**PATERSON  
SIMONS**

# **IMPORTANT EQUIPMENT ANNOUNCEMENT**

**Machines: All GMK Models with boom/rope  
guard strips or rollers**

**Content: Addition to the Operation Manual**

#### Checking the guard strips

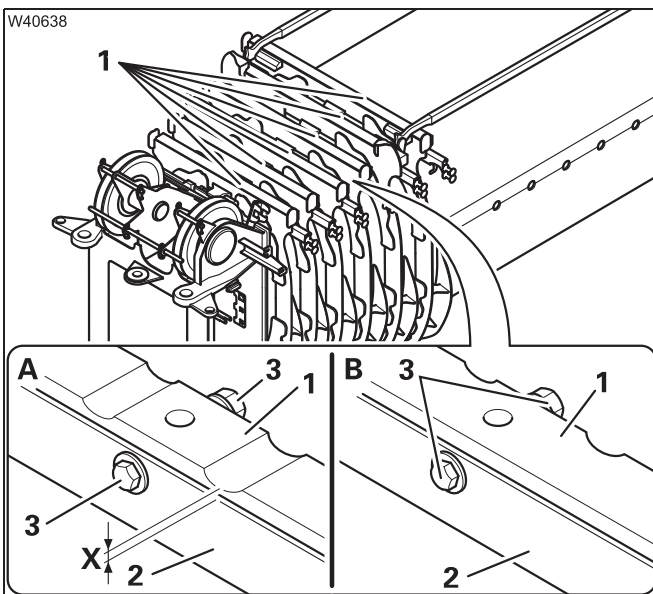
The figure shows the main boom on a GMK5250L truck crane. Other GMK models have a similar arrangement of guard strips (1) on the upper surface of the telescopic sections.

The guard strips (1) are *replaceable parts* that must be checked regularly.

The hoist rope can form grooves in the guard strips when the crane is used intensively. The hoist rope and telescopic section will be damaged when the groove depth reaches the metal of the telescopic section.

- Check all guard strips (1) on all telescopic sections for damage, wear and formation of grooves by the hoist rope.

You can turn the guard strip, but only when the bottom of the groove lies significantly above (X) the telescopic section (2).

You must therefore turn or replace the guard strips in time (1).

- (A) – Remove all screw connections (3).
- Remove the guard strip (1) and clean the guard strip and the top surface of the telescopic section.
- (B) – Turn the guard strip (1) by 90° and fasten all screw connections (3).

- Have the damaged guard strips replaced by **Manitowoc Crane Care** or an authorised GROVE dealer or your qualified repair crew.

### Conversion from plastic guard strips to steel rollers

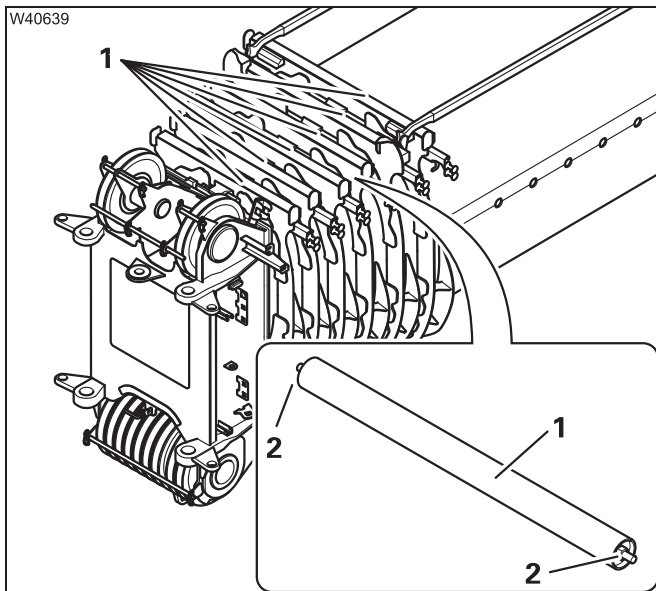
The GMK 5250L and GMK 6300L truck cranes can be delivered with/converted to steel rollers running in ball bearing races as **additional equipment**.

- Contact **Manitowoc Crane Care** for information on the details and cost of a conversion.
